Addendum No. 3

RFP No. 23-28 DHS DFCS OFFICE RENOVATION

March 18, 2024

DRAWING OF 603 WALK UP 25-3/4"W x 42"H

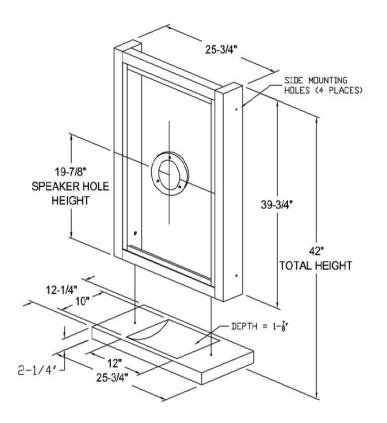
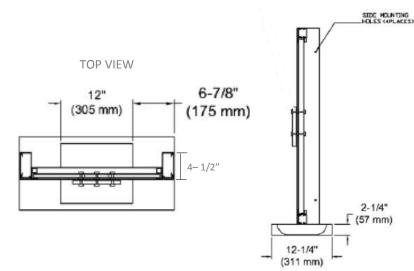
<u>I.</u> <u>**Question**</u>: Please provide the details/cut sheets for openings and windows in reception and CSS rooms on 1/A900.

<u>Answer</u>: Transaction window to be similar to design intent of the following: <u>Ready Access</u> – 603 Cashier Window with Deal Tray (Interior, Single Pane)
